CITY OF FALLS CHURCH

MEMORANDUM

RE: ***Mason Row/Founders Row Site Plan and Subdivision (Consolidation) Plat (Munis #2013-1165) Submission 3*** – Site plan and subdivision (consolidation) applications for mixed-use project by Mill Creek Residential and Spectrum Development LLC for properties known as 916, 920, 922, 924, 926, 928, 930, 932 & 934, West Broad Street and 919, 921 & 925 Park Avenue (Real Property Code #s 51-202-009 through 51-202-015, 51-202-003, 51-202-004, 51-202005, 51-202-028 and 51-202-028 Outlot)

The City staff has reviewed the 3rd Submission for the above referenced application package for the Mason Row/Founders Row mixed-use development dated July 10, 2018 that includes the following documents:

GRADING PLAN
FOUNDERS ROW
 AT THE INTER SECTION OF WEST BROAD STREET,
 NORTH WEST STREET & PARK AVENUE
 CITY OF FALLS CHURCH, VIRGINIA

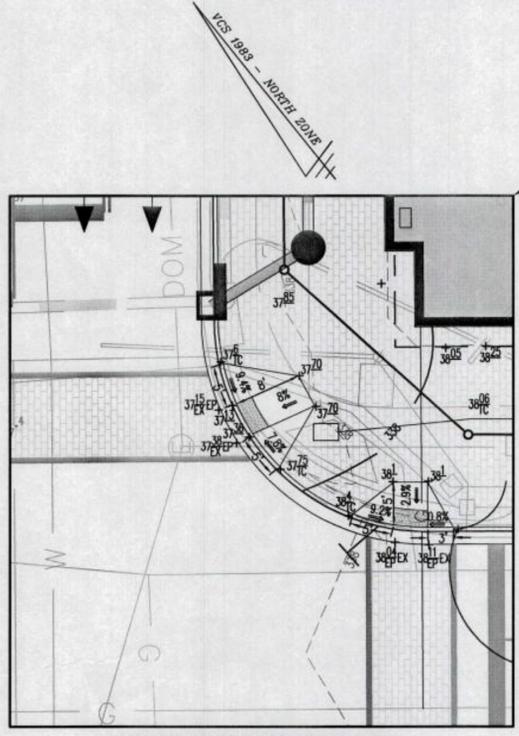
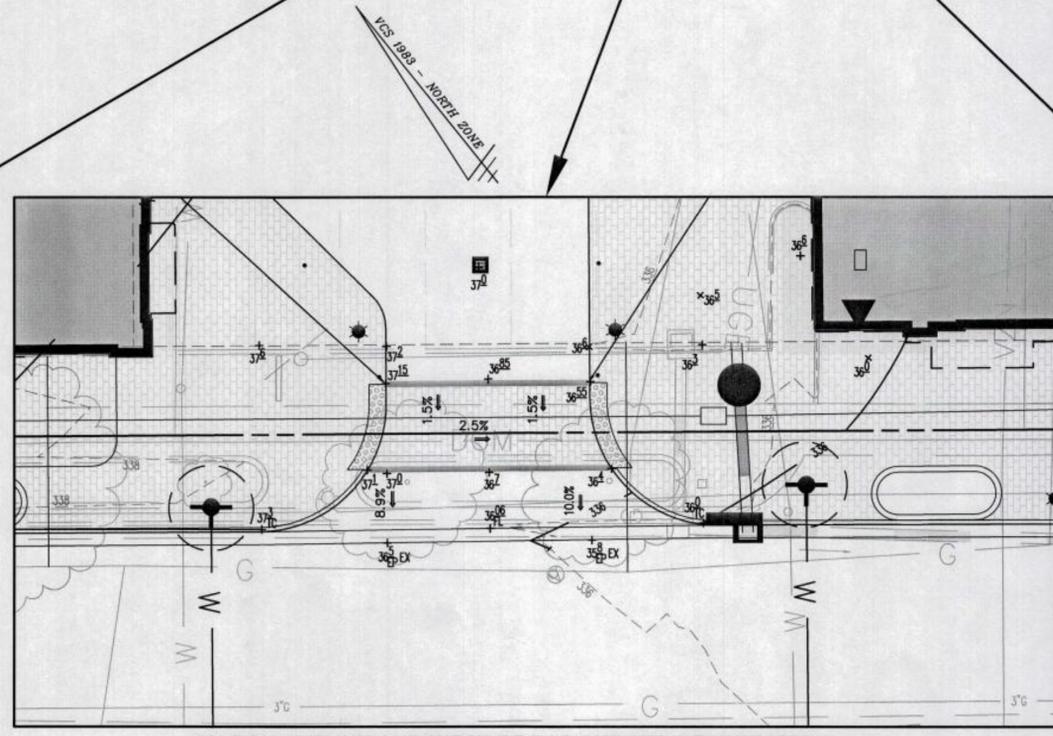
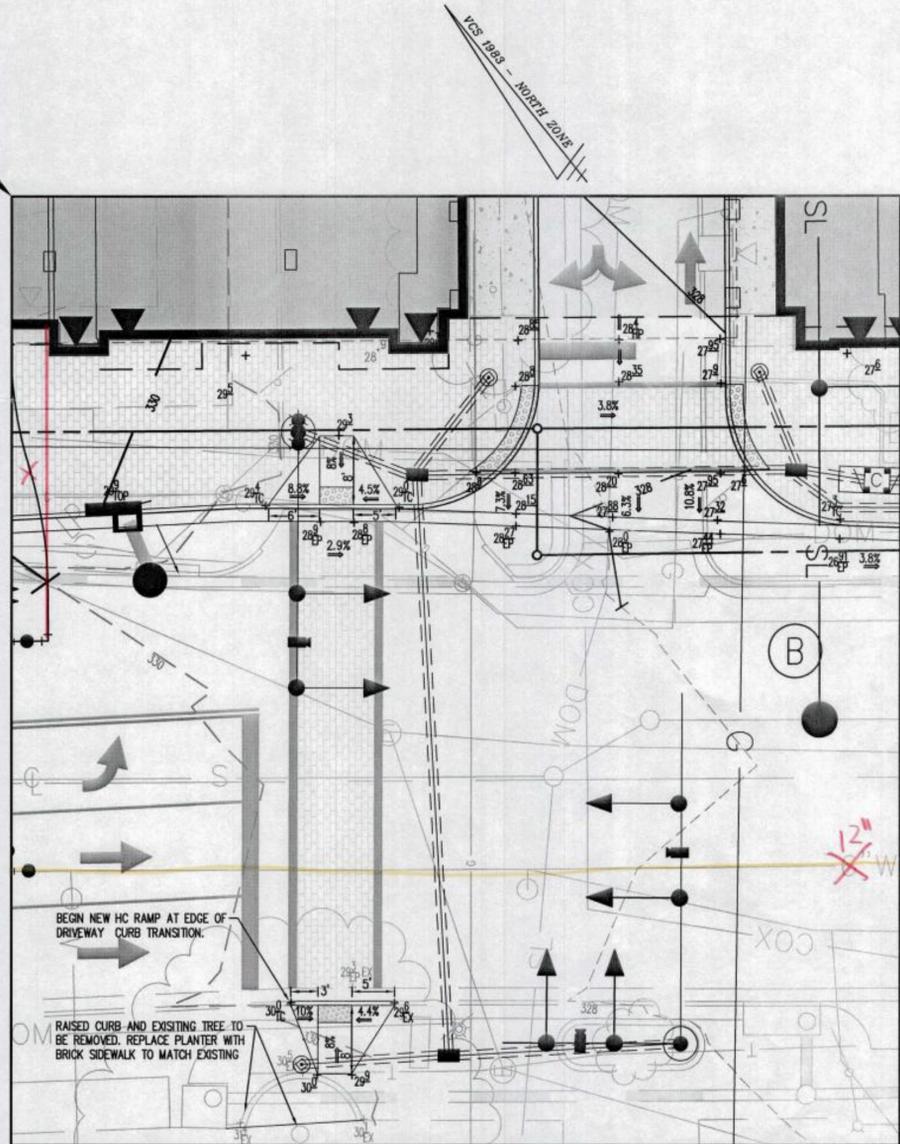
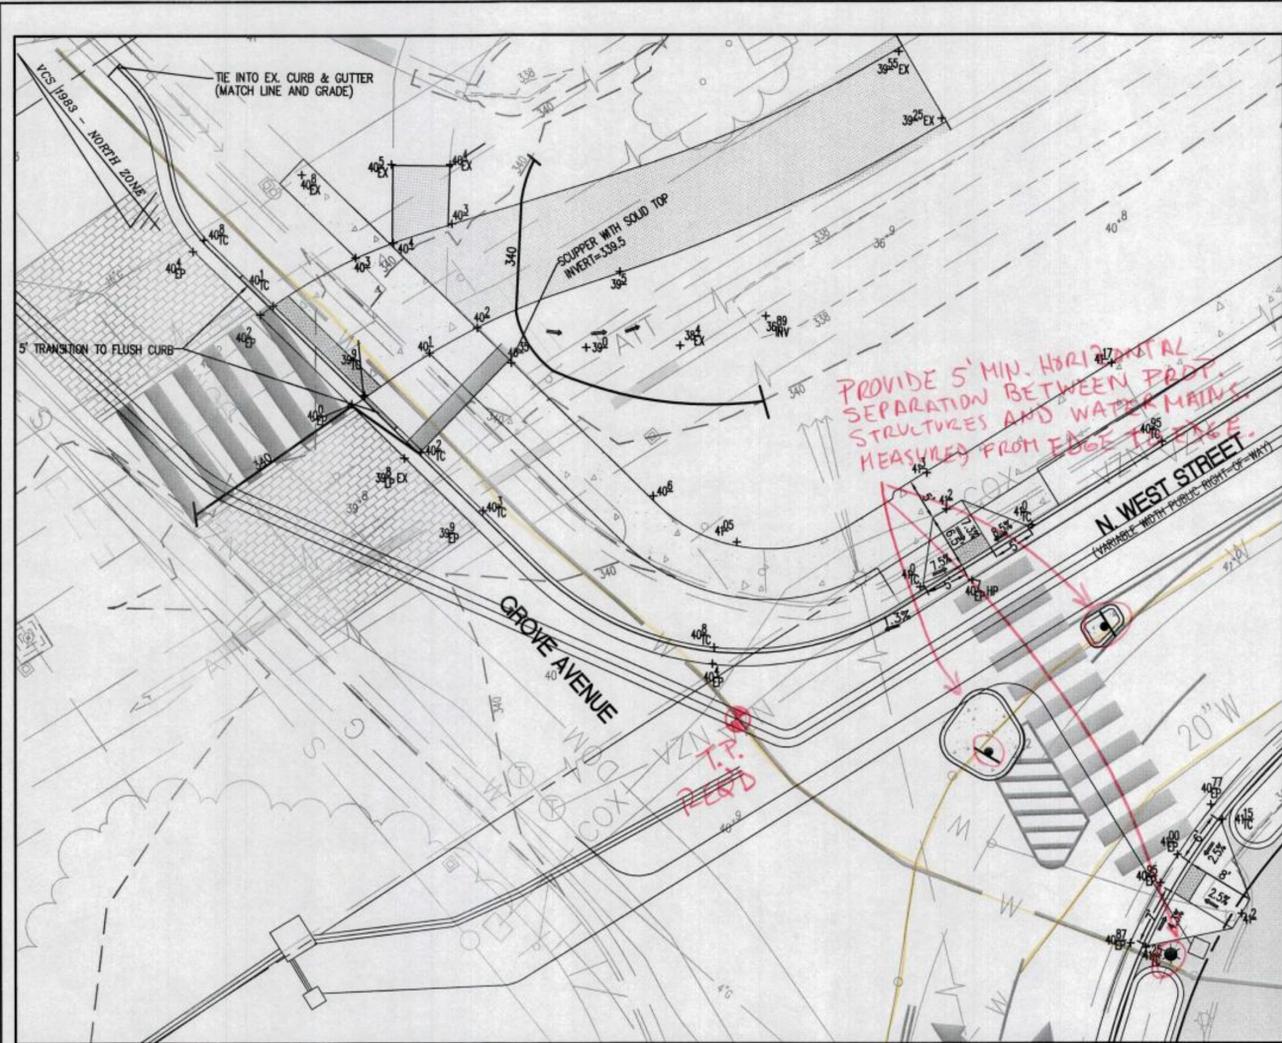
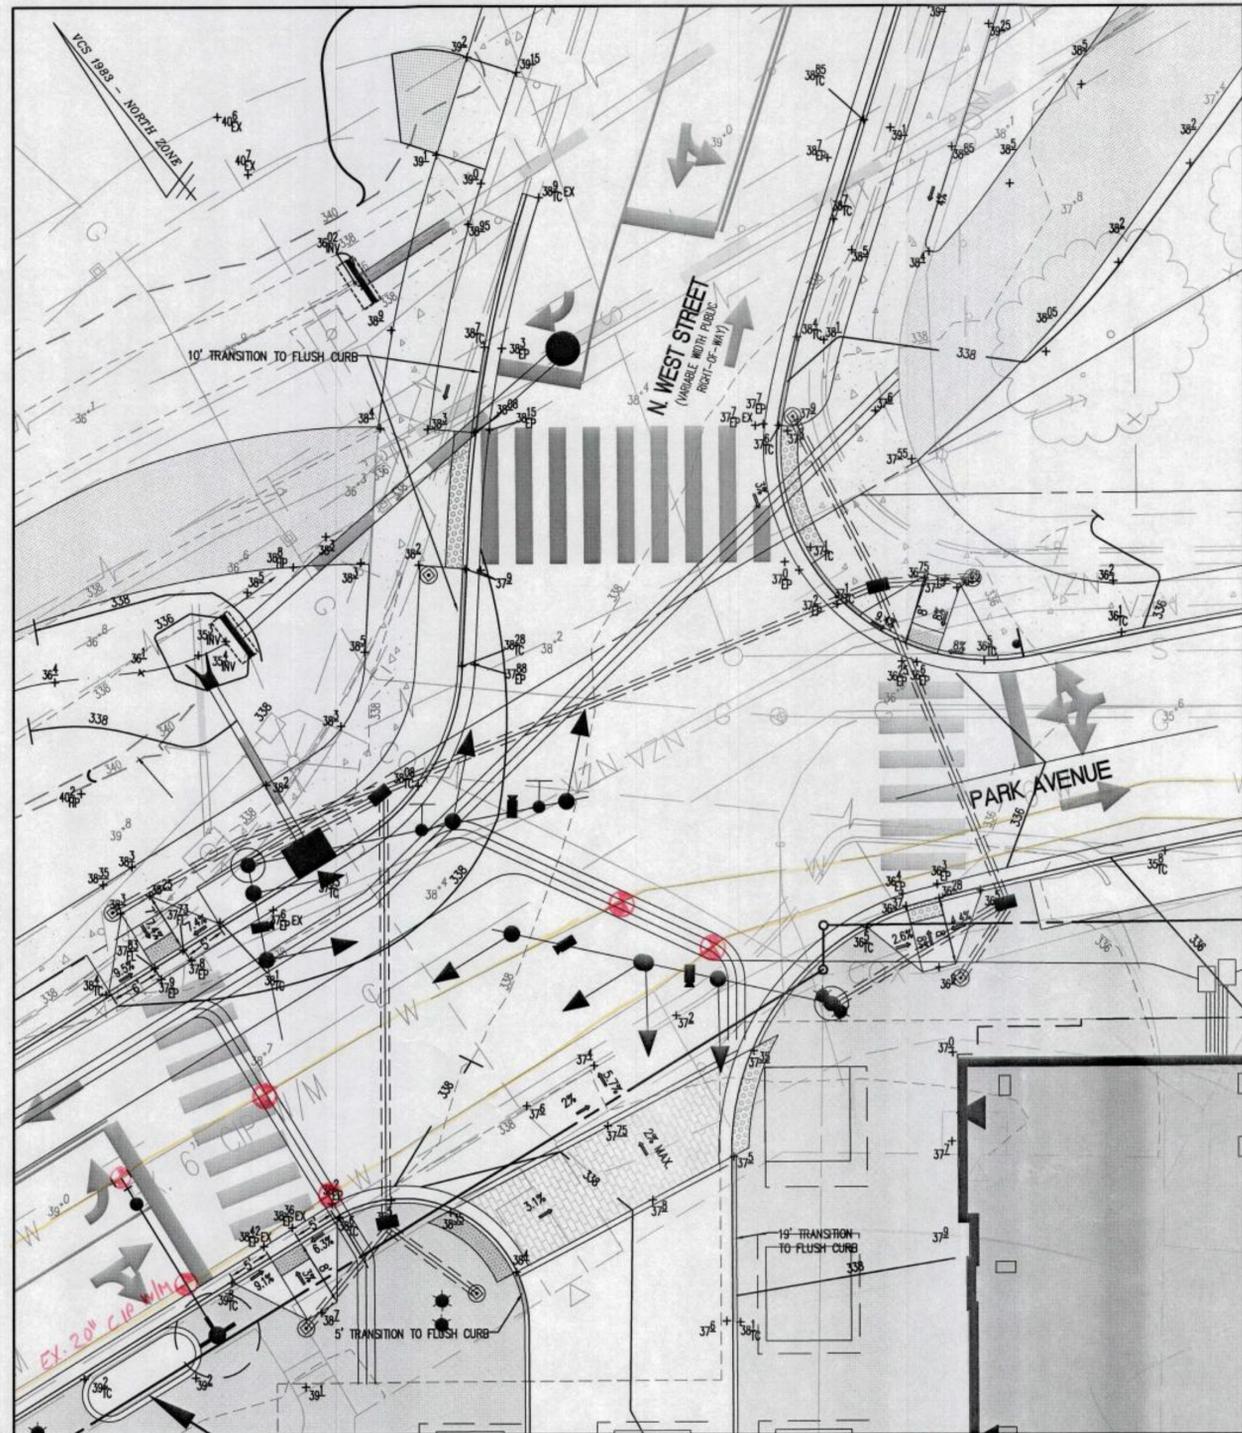
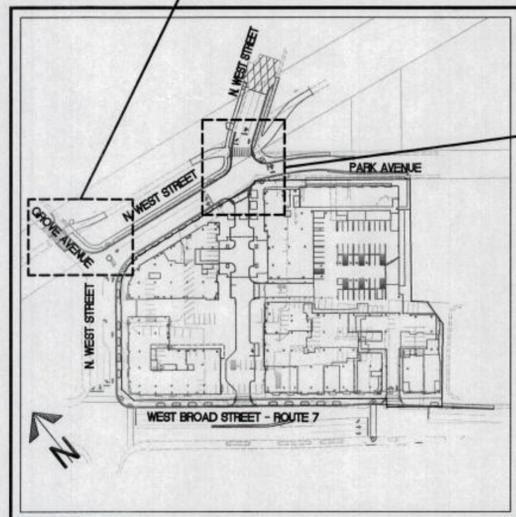
X SEE COMMENTS ON SHEETS C 301, 401

* SEE COMMENTS ON SHEET C301, 401

GRADING ENLARGEMENT

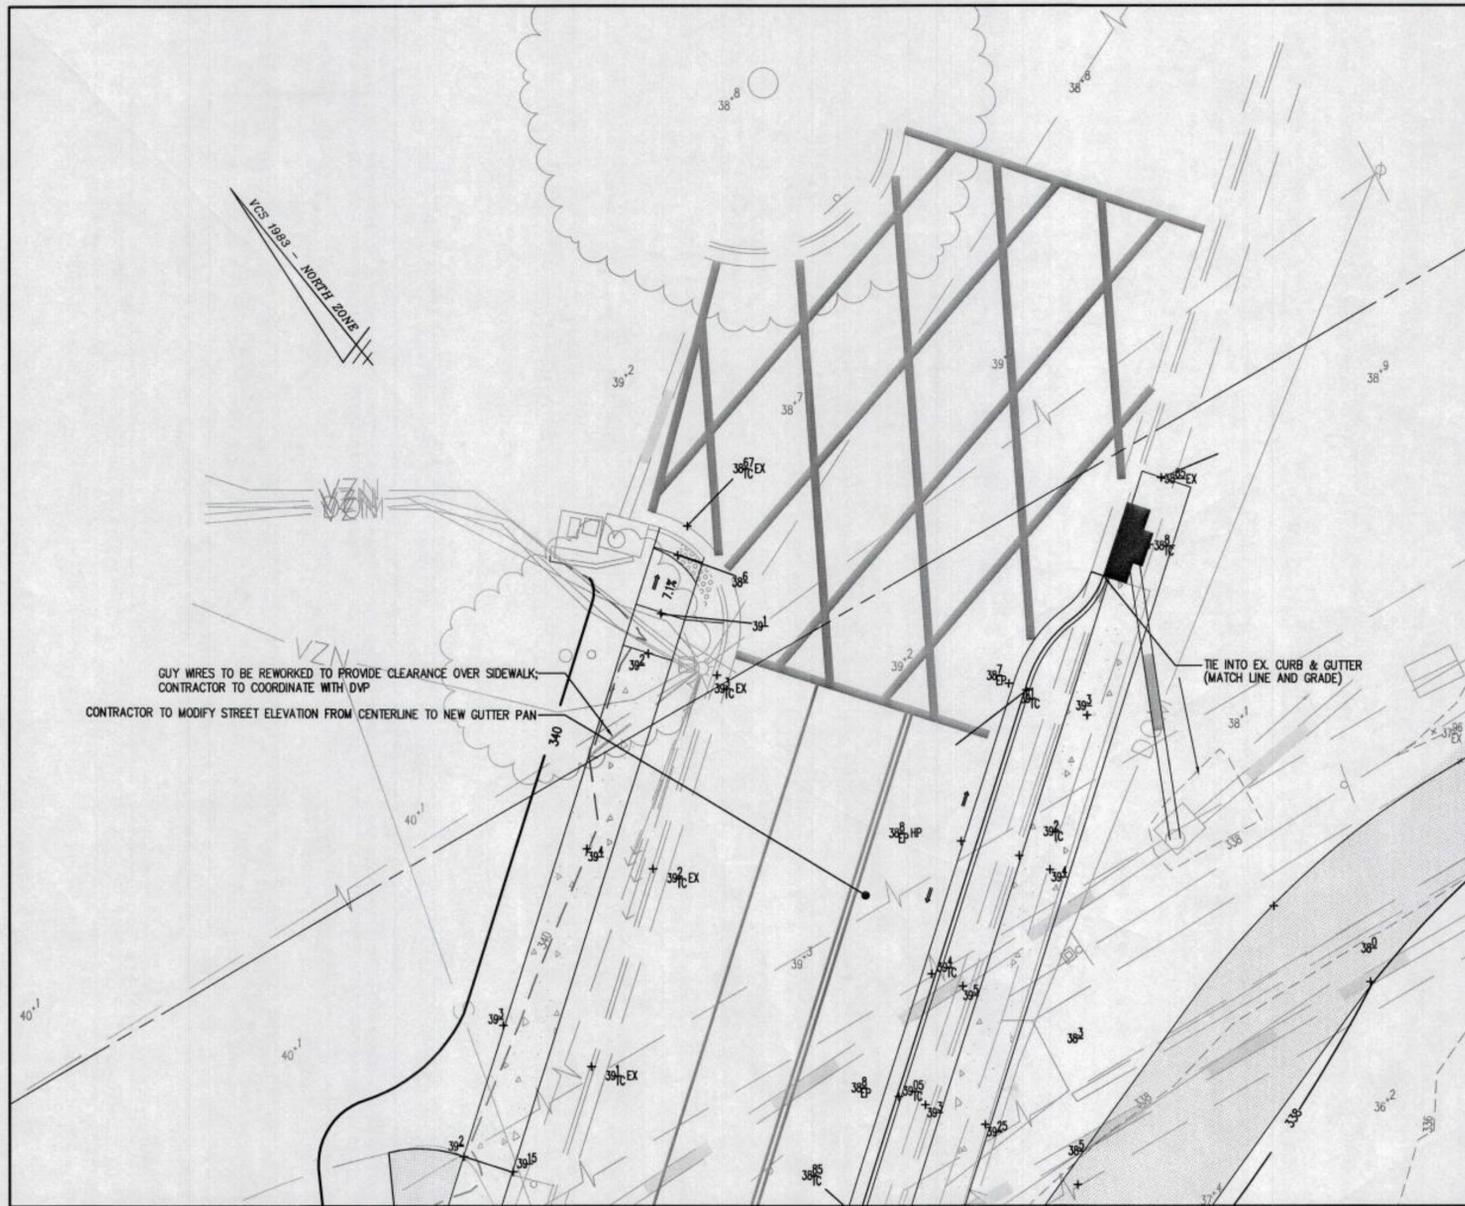
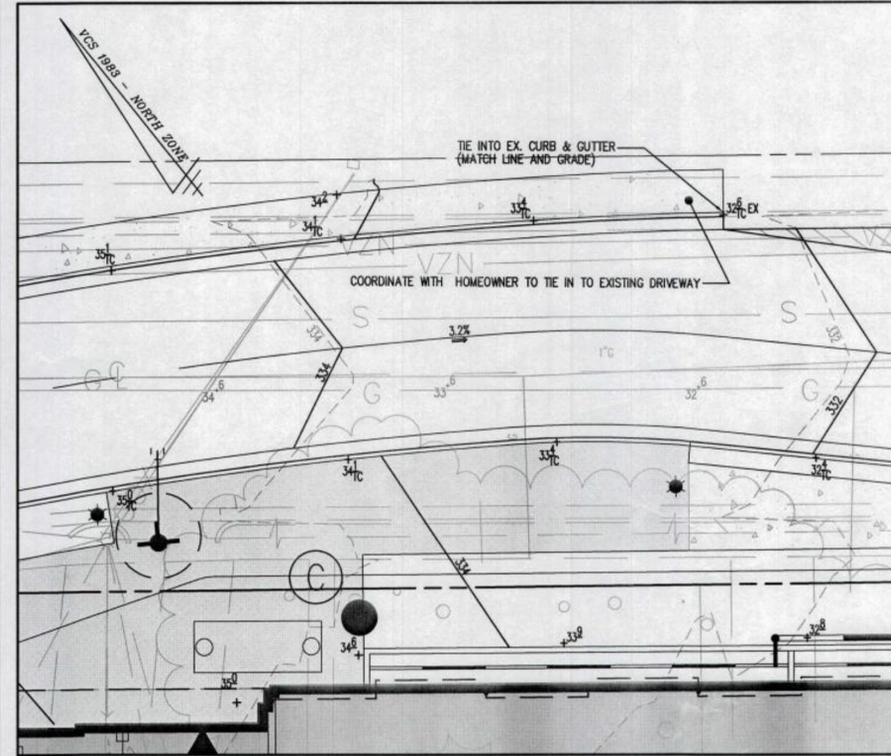
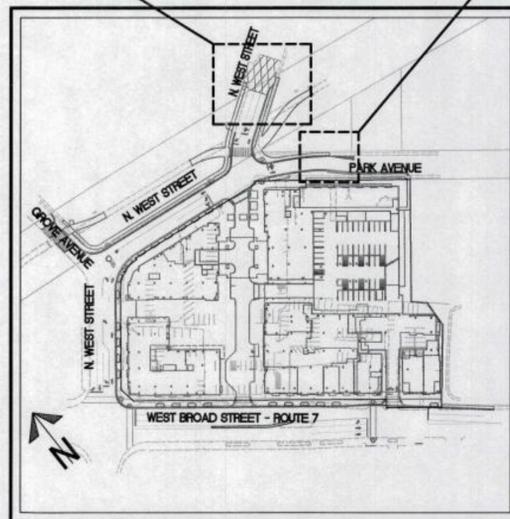
* SEE COMMENTS ON SHEETS C-301, 401
 * DEPICT EX. WATER MAINS AND APPURTENANCES CALL OUT SIZE, MATERIAL.
 * SHOW EX. F.H. #40-4-140

UTILITY PROFILES

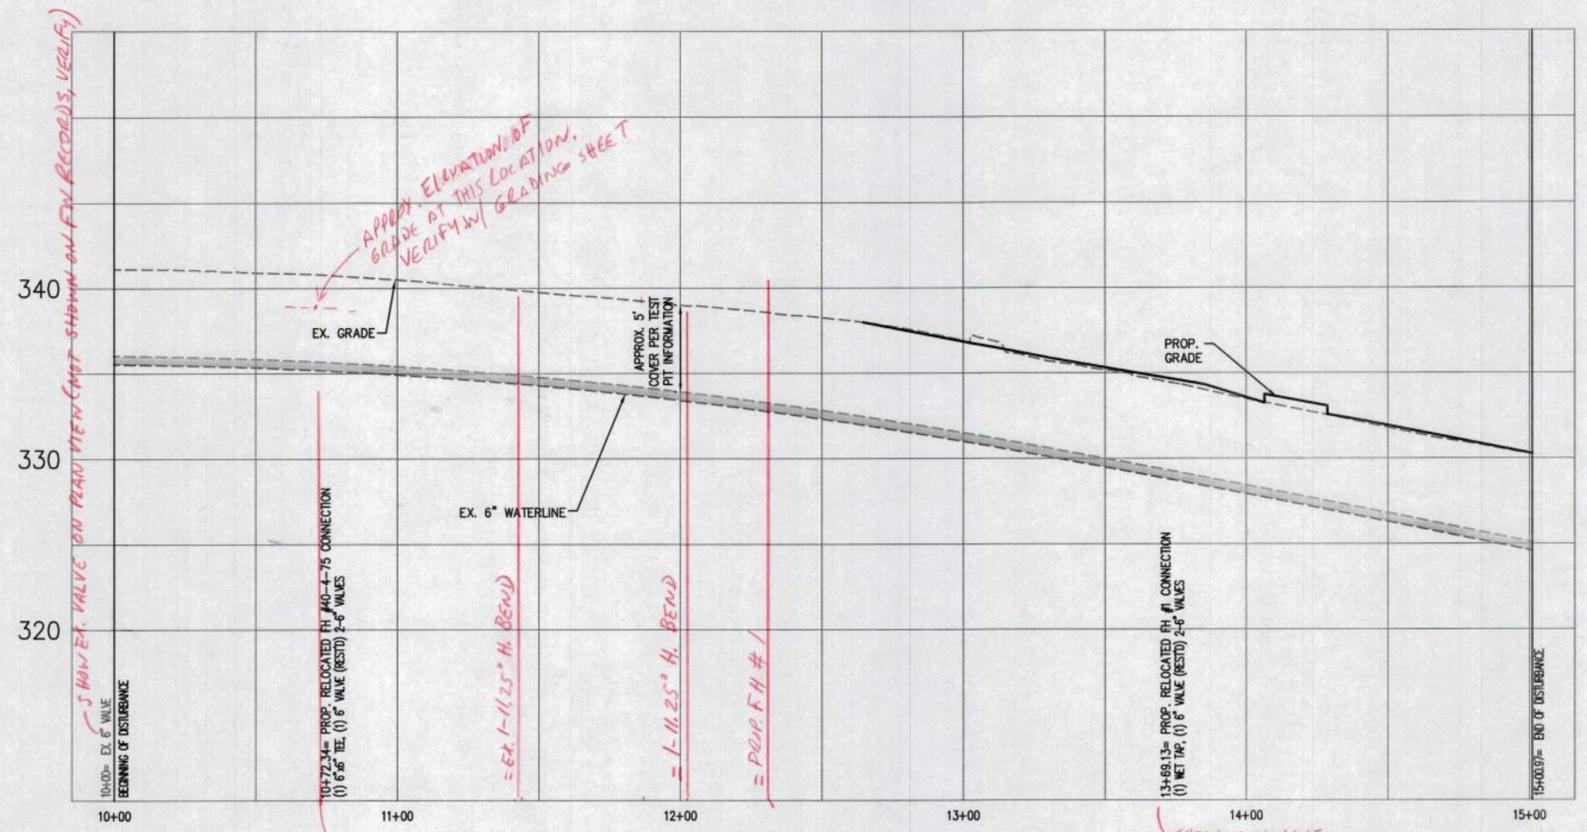
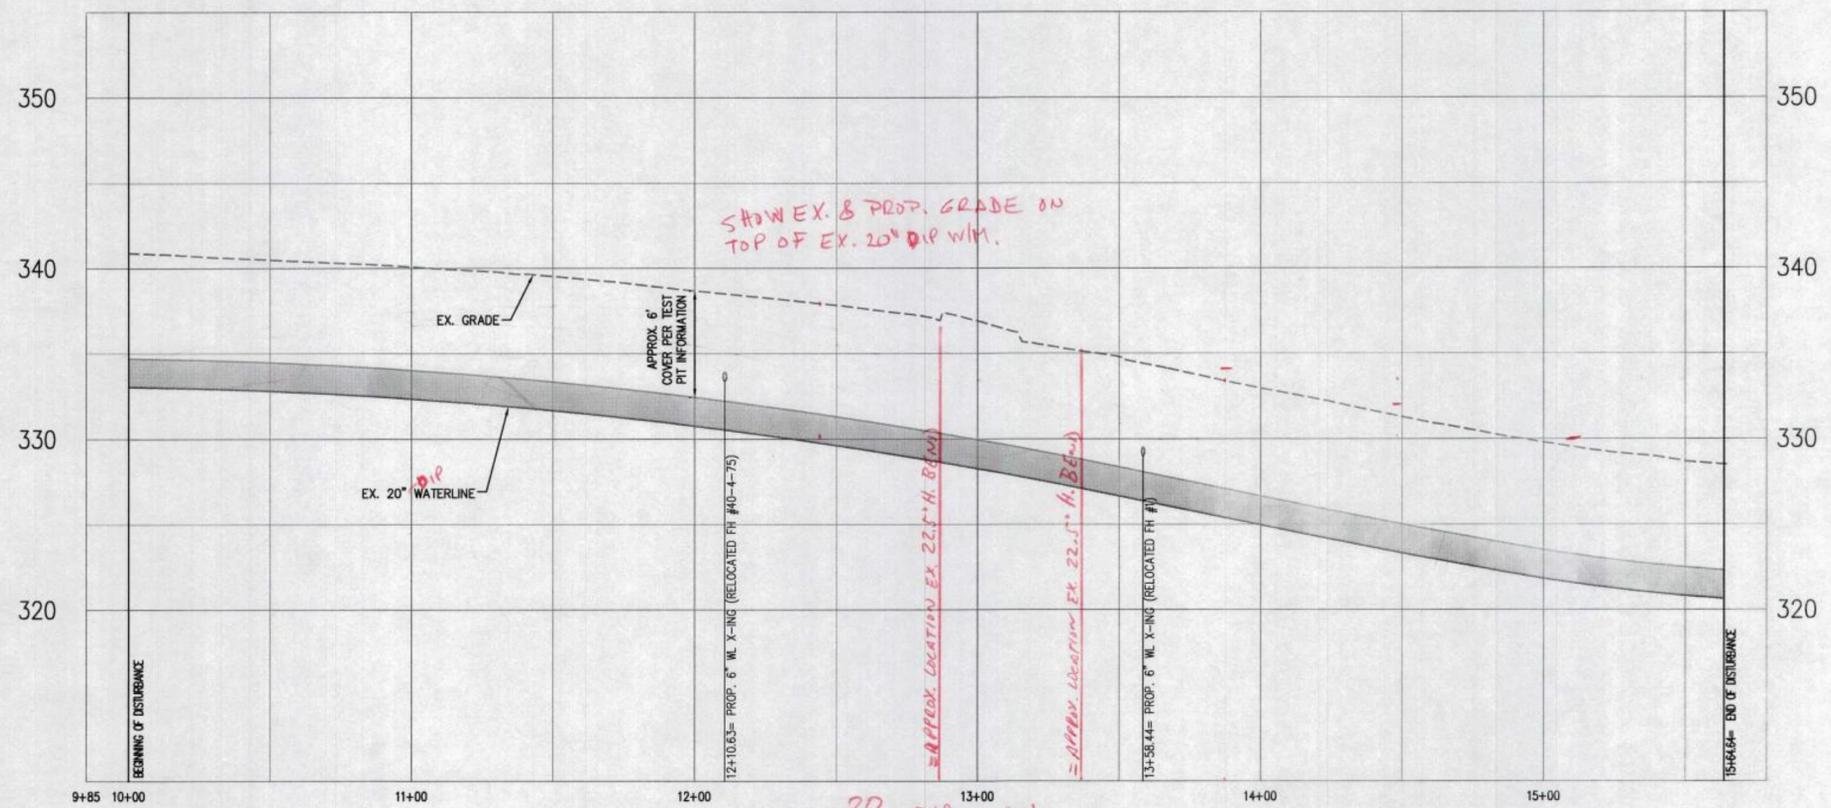
APPROX. ELEVATIONS OF GRADE AT THIS LOCATION. VERIFY W/ GRADING SHEET

UPDATE PROFILE

SHOW XING. LINE. STATIONS AND LOCATION OF HYDRANTS DO NOT MATCH PLAN VIEW SHEET. DISTANCE FROM FH 40-4-75 TO PROP. F.H. #1 IS $\approx 15'$ ALONG EX. 6" WATER MAIN. * SHOW EX. FITTINGS. * SEE COMMENTS ON SHEETS 301, 401,

SHOW EX. & PROP. GRADE ON TOP OF EX. 20" DIP WITH.
